DART AEROSPACE LTD	Work Order:	112948
Description: Crosstube Assembly (206B High Fwd)	Part Number:	D206-667-141
Inspection Dwg: D206-667-141 Rev: C		Page 1 of 2

DRAWING NO. D206-667-141	TITLE CROSSTUBE ASS'Y (206B HIGH FWD)	REV. C	DART AEROSPACE LTD ENGINEERING ORDER		D.E.O. NO. D206-667-141-C-1	SHEET NO. SHEET 1 OF 1	SCALE NTS
DRAWN <i>Q</i>	CHECKED <i>ASS</i>	MFG. APPR. <i>MD</i>	APPROVED <i>MD</i>		DE APPR. <i>MD</i>		
DATE 11.07.15	DATE 11.07.20	DATE 11.07.21	DATE 11/07/21		DATE 11.07.21

DRAWING NO. D206-667-141	TITLE CROSSTUBE ASS'Y (206B HIGH FWD)	REV. C	DART AEROSPACE LTD ENGINEERING ORDER		D.E.O. NO. D206-667-141-C-2	SHEET NO. SHEET 1 OF 1	SCALE NTS
DRAWN AJS	CHECKED	MFG. APPR.	APPROVED		DE APPR.		
DATE 12.08.02	DATE 12.08.02	DATE 12.08.02	DATE 12.08.02		DATE 12.08.02

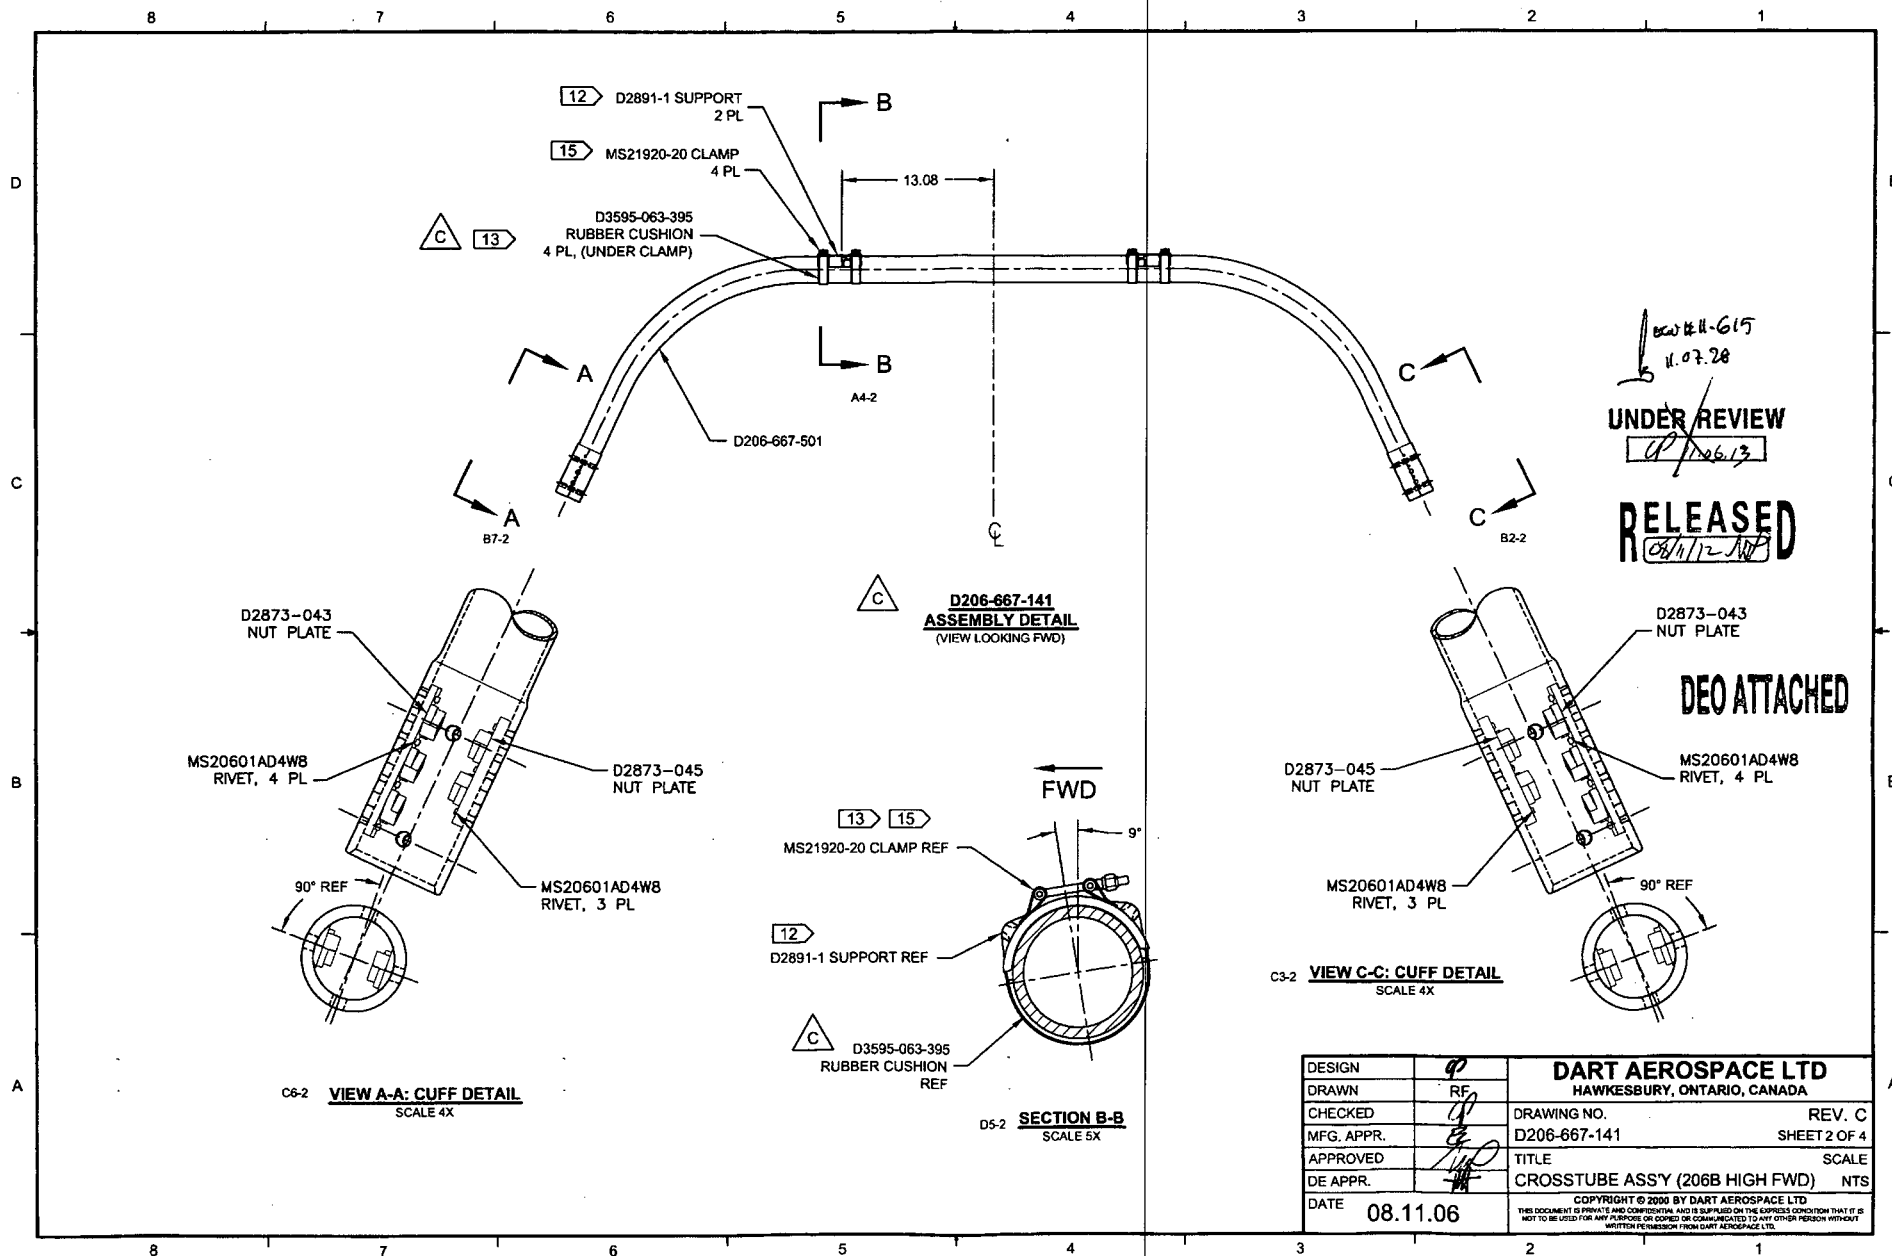
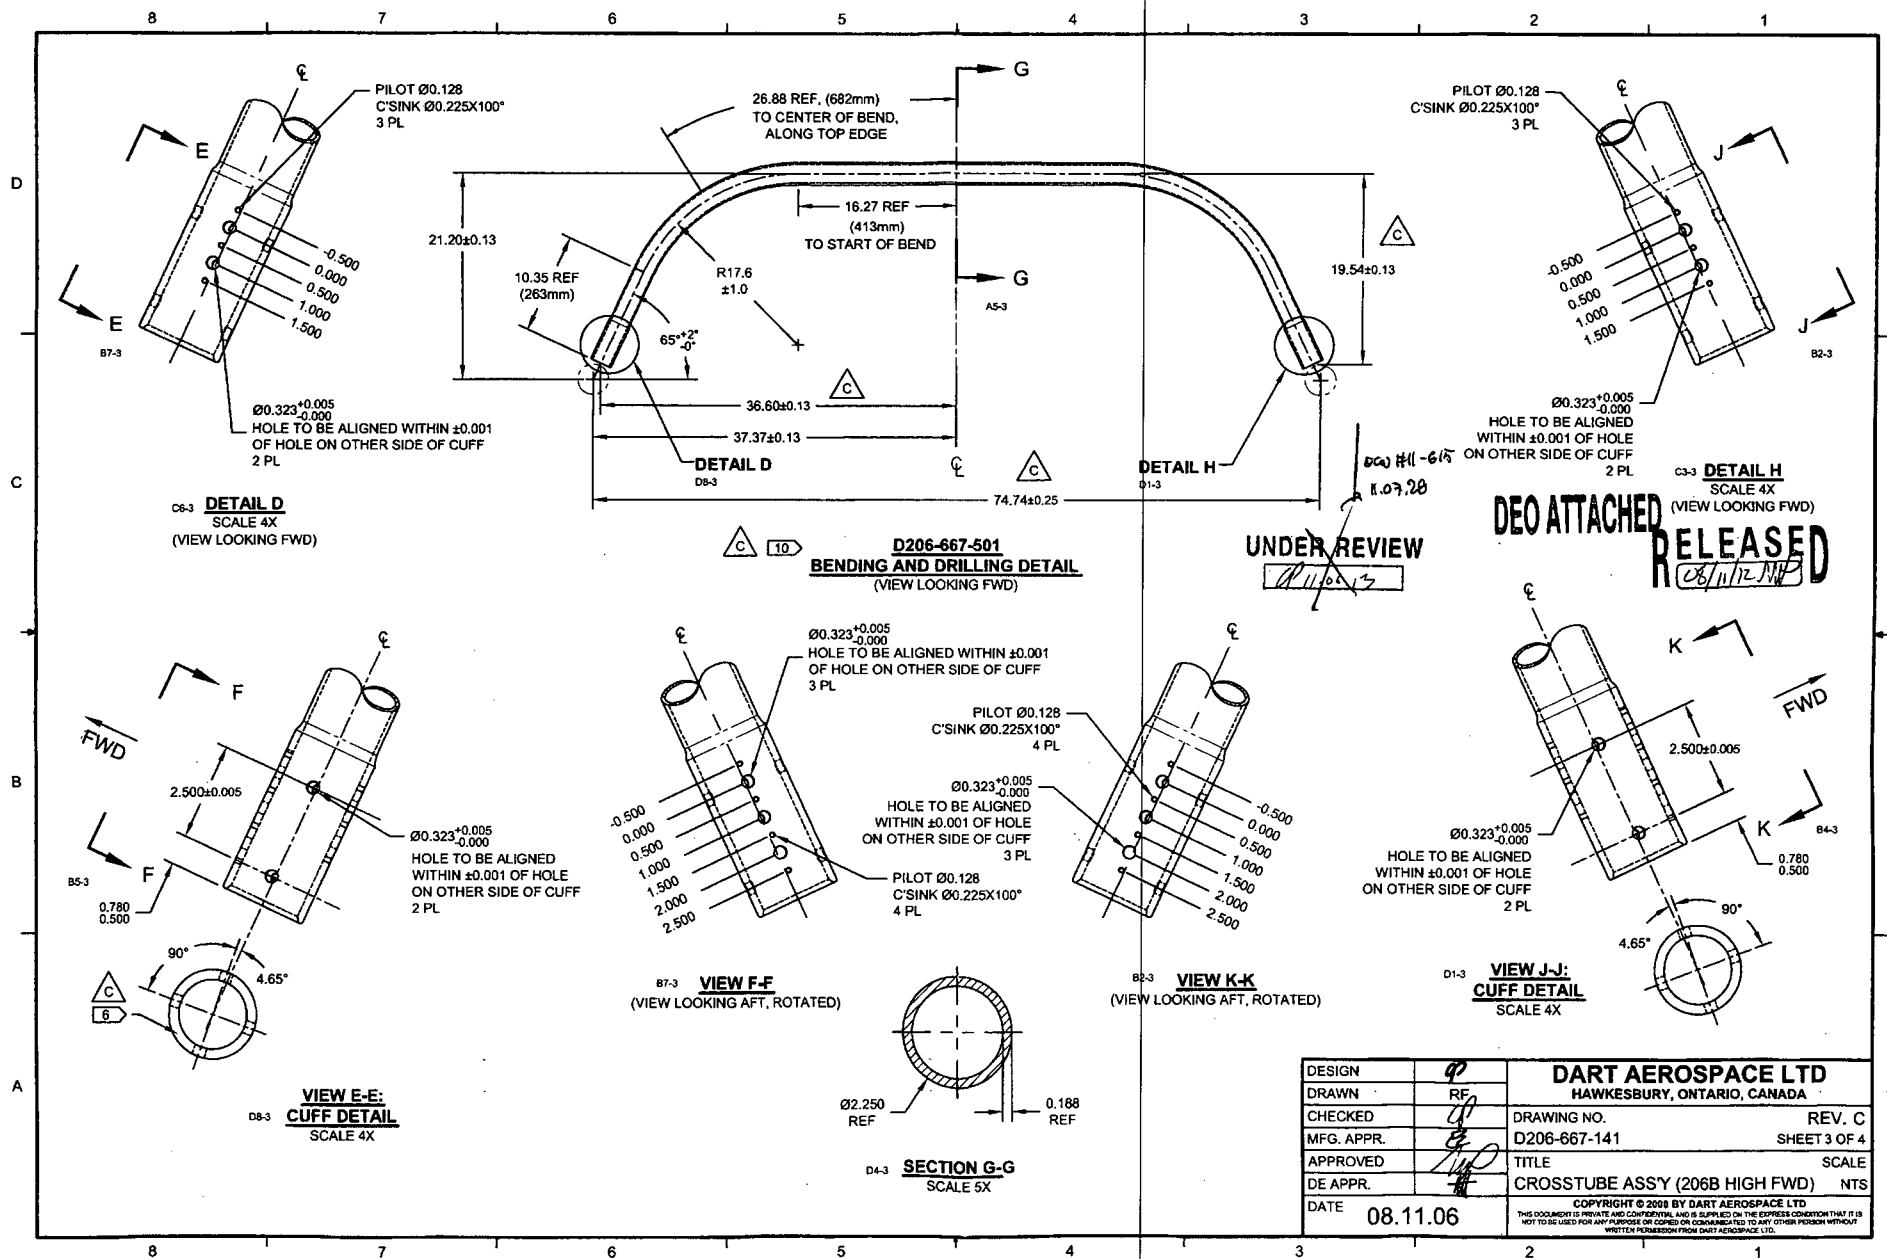
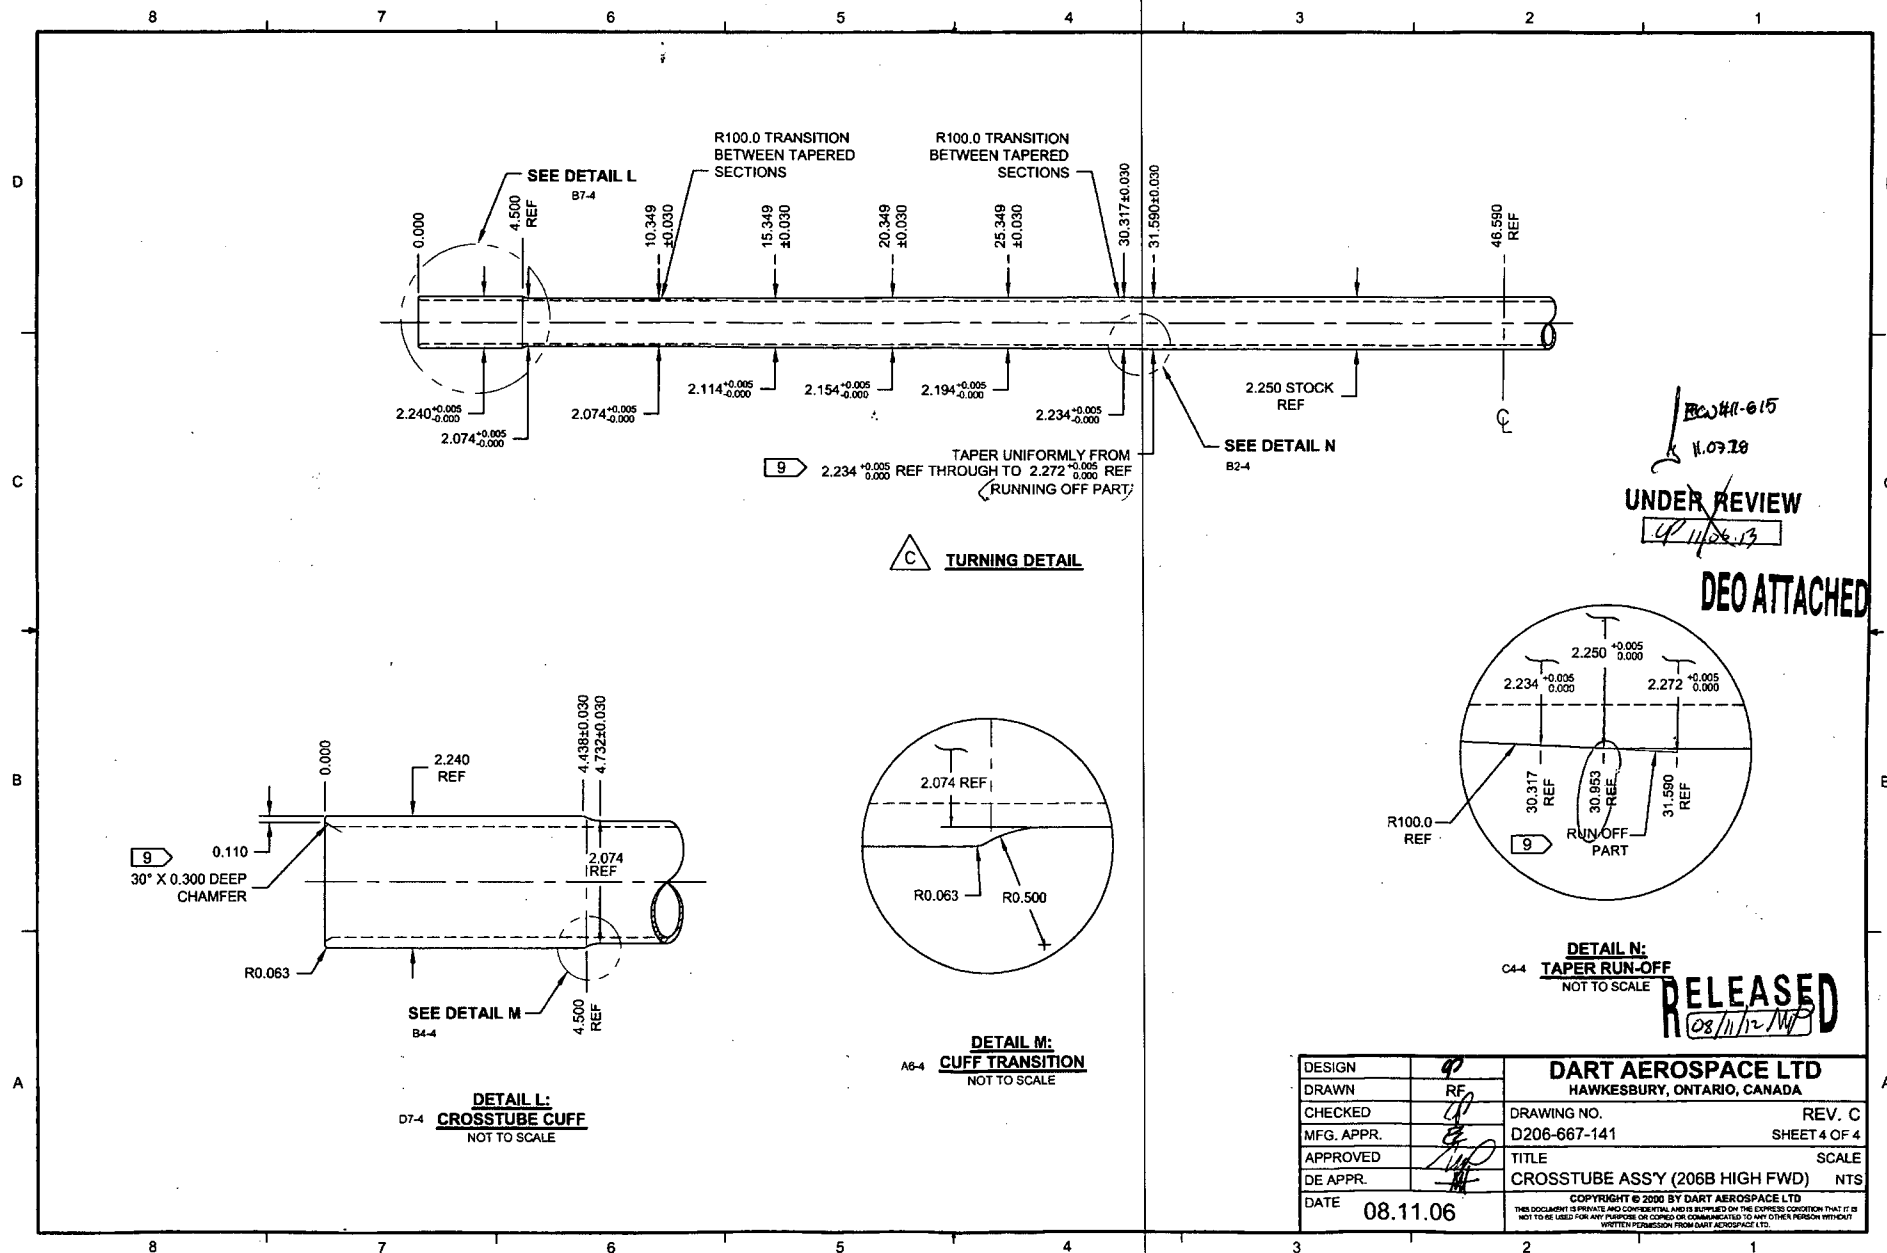
REPLACE MAGNOBOND WITH PROSEAL.

Item	Qty -141	Part Number	Description
9	A/R	PROSEAL 890 B-2	SEALANT, AMS-S-8802 CLASS B-2

9	A/R	MAGNOBOND 6398	ROCKWELL SPECIFICATION RBO-120-023 ADHESIVE (TEXTRON/BELL SPEC. 299-947-100, TYPE II, CLASS 2 ADHESIVE)
---	-----	----------------	---

- 12) TO INSTALL D2891-1 SUPPORT: ABRASE MATING SURFACE OF SUPPORT AND CROSSTUBE WITH 180-GRIT SANDPAPER AND REMOVE RESIDUE WITH MEK (OR EQUIVALENT). APPLY A 0.04" TO 0.07" THICK LAYER OF PROSEAL 890 CLASS B-2 (OR AMS-S-8802 CLASS B-2) SEALANT TO MATING SURFACE OF SUPPORT.
- 15) TORQUE CLAMPS 80 TO 100 IN-LB. ENSURE AT LEAST 1.5 THREADS SHOWING IN SAFETY AND THAT NUT HAS NOT BOTTOMED-OUT AFTER TORQUING. **PRIOR TO PACKAGING, RE-CHECK TORQUE ON CLAMPS AFTER PROSEAL 890 SEALANT HAS CURED FOR 72 HOURS.**

- 12) INSTALL D2891-1 SUPPORT USING 0.03" TO 0.06" THICK LAYER OF MAGNOBOND 6398 PER QSI 015. LET CURE FOR 12 HOURS AFTER INSTALLATION AND PRIOR TO PACKAGING.
- 15) TORQUE CLAMPS 80 TO 100 IN-LB. ENSURE AT LEAST 1.5 THREADS SHOWING IN SAFETY AND THAT NUT HAS NOT BOTTOMED-OUT AFTER TORQUING.

DETAIL P
BONDING STRAP INSTALLATION 2 PL

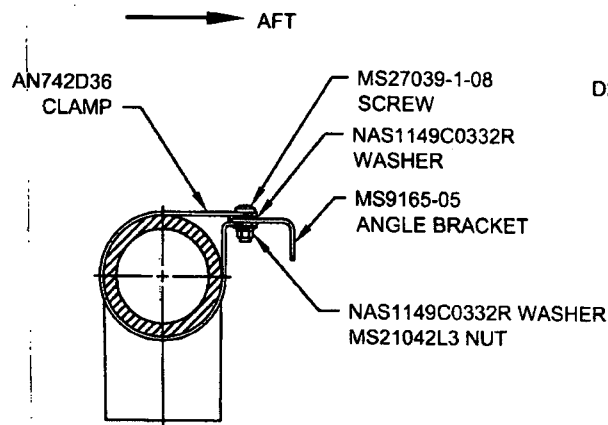
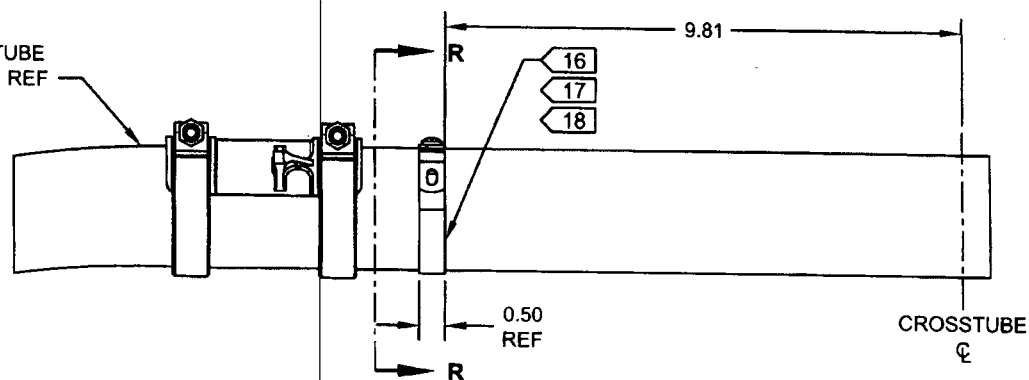
ADD ELECTRICAL GROUNDING STRAP

ITEM	QTY	PART NUMBER	DESCRIPTION
1	X	D206-667-141	CROSSTUBE ASSEMBLY (206B HIGH FWD)
10	2	AN742D36	CLAMP
11	2	MS9165-05	ANGLE BRACKET
12	2	MS21042L3	NUT (OR MS21042-3)
13	2	MS27039-1-08	SCREW
14	4	NAS1149C0332R	WASHER (OR AN960C10L)

- 16) MASK AREA UNDER CLAMP PRIOR TO PAINTING
- 17) SEAL EDGES WHERE AN742D36 CLAMP MEETS WITH THE CROSSTUBE USING SIKAFLEX-241/-291 OR MIL-S-8802 CLASS B2 OR PROSEAL 890 SEALANT
- 18) PERFORM RESISTANCE CHECK TO ENSURE MAX RESISTANCE IS 10 MILLIOHMS
